Interoffice Memorandum

October 23, 2024

**Subject: Colowyo Mine (Permit No. C-1981-019)
2023 AHR Review**

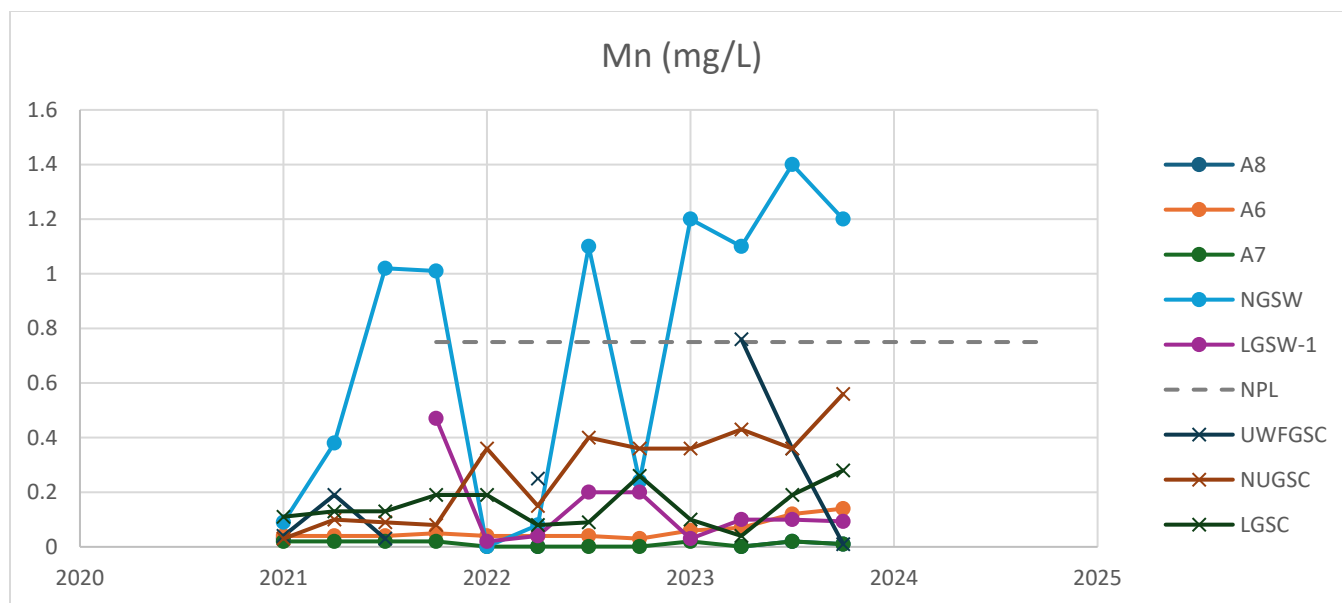
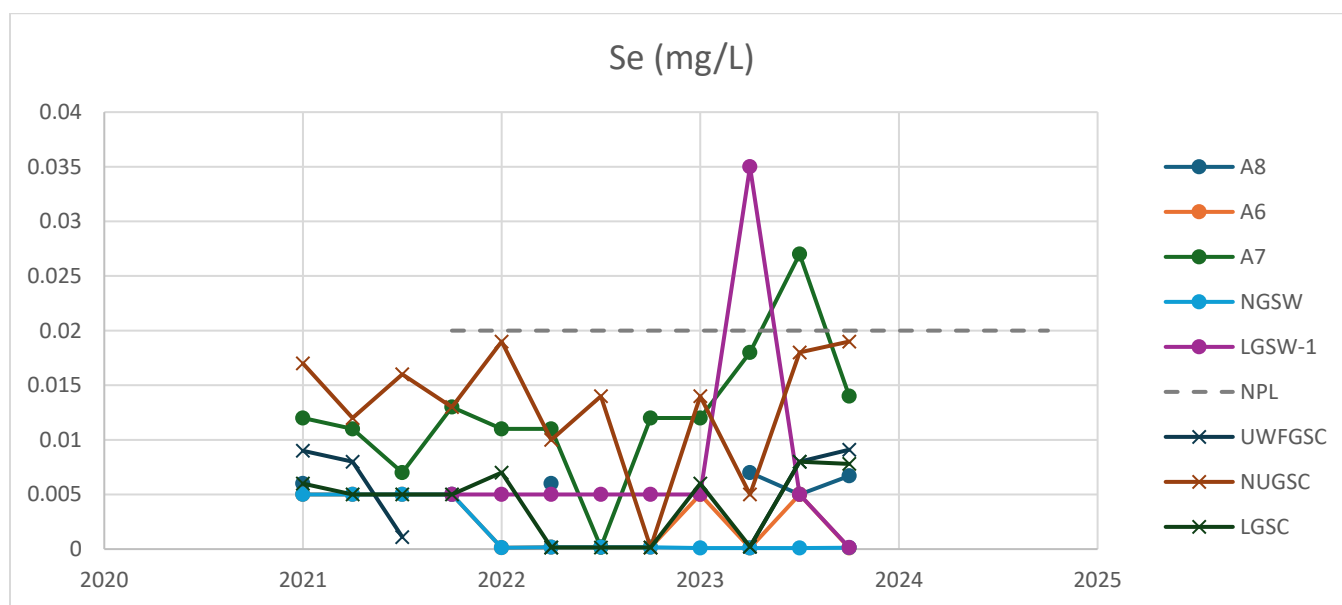
Total Dissolved Solids and Sulfate concentrations follow similar patterns in Good Spring Creek. Firstly, the concentration of each generally increases from upstream/upgradient to downstream/downgradient. There is considerable variability in the data from the three surface water monitoring locations, and much less variability in the groundwater data; the new groundwater monitoring point, LGSW-1, is the exception – it shows a large spike in both parameters in early 2023, followed by a sharp drop in the third and fourth quarters. It will be necessary to continue monitoring for trends, and to assess long-term water quality against the standard. For now it should be noted that both parameters have exceeded the compliance standard multiple times over the relatively short monitoring period, but were in compliance at the end of 2023.

Manganese concentrations at NGSW have been notably high at times, and also quite variable. It is interesting to note that elevated Manganese levels have not been observed at LGSW-1 to date.

An exceedance of the Selenium NPL was reported at LGSW-1 in the second quarter of 2023, but this appears to be an anomaly. The Selenium NPL (based on table values from Reg. 41 The Basic Standards for Groundwater) is quite low, and the scale used on the y-axis is such that very small variations in sampling or analysis procedures lead to variability in the data. The data shown does not suggest either an increasing trend or a chronic exceedance.

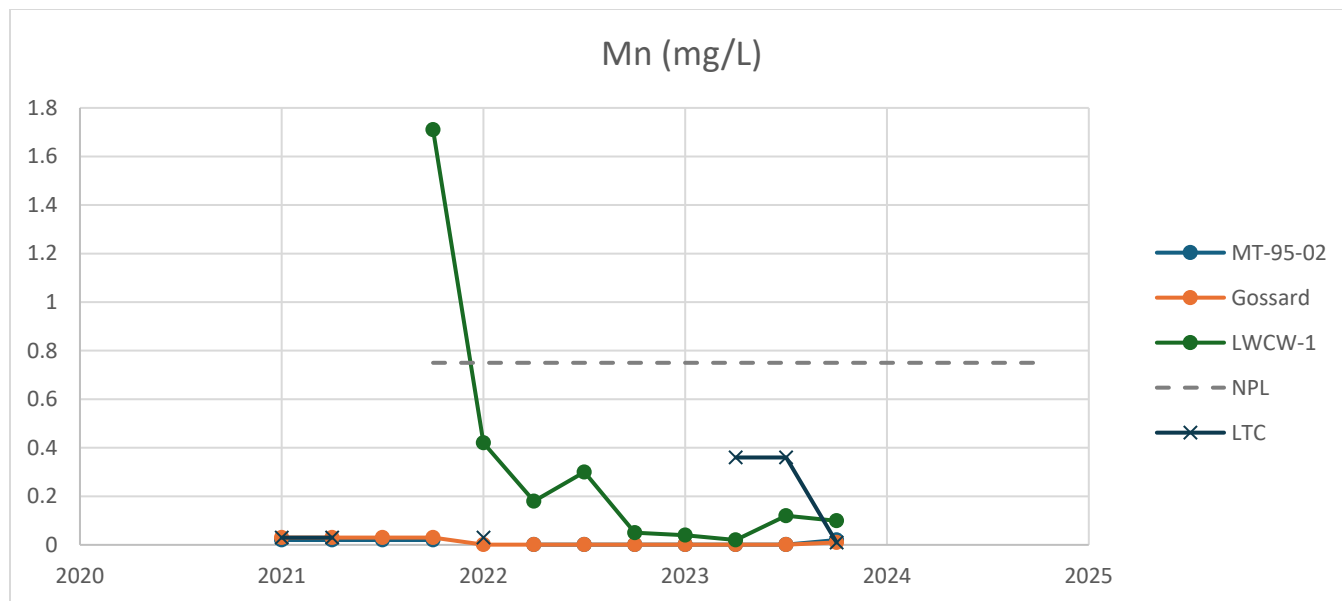
TDS in Wilson/Taylor Creek shows an interesting trend, with very high values in the ephemeral Taylor Creek and its alluvium (at MT-95-02), and lower values in the Wilson Creek alluvium at the Gossard Well. At the most downstream location (LWCW-1, the Point of Compliance), the measured values have remained below the NPL, and show a decreasing trend throughout 2023.

A significant exceedance of the NPL for Manganese was reported at LWCW-1 in Q4 of 2021, but since then the levels have dropped and remained well below the standard of 0.75 mg/L. No other upstream monitoring locations have shown elevated Manganese over the period.

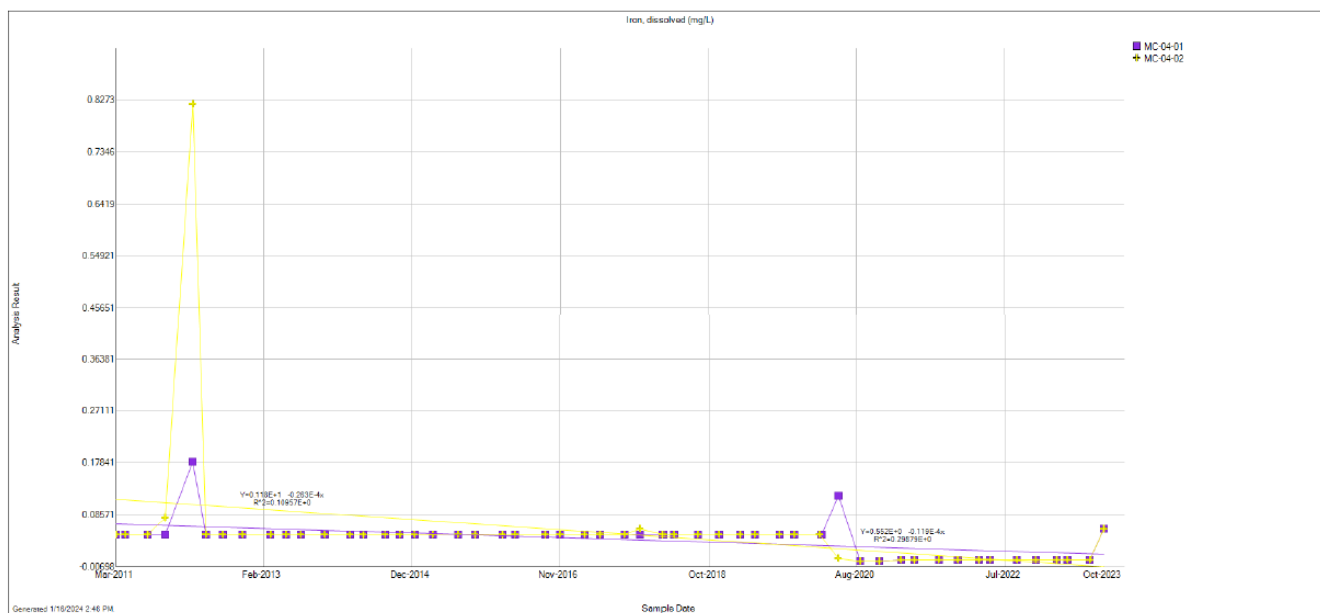
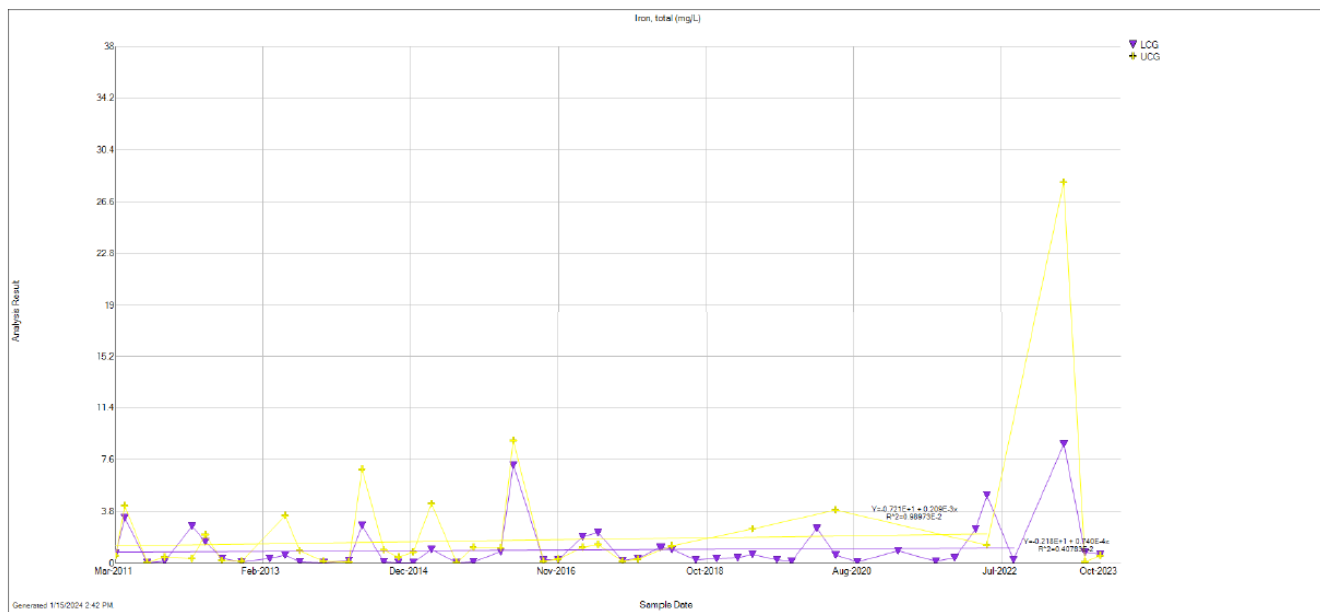
A significant spike in Iron was reported at both Collom Gulch surface water monitoring locations in 2023, as is obvious on the graph presented in the AHR (copied below). The same spike was not seen in the groundwater data.
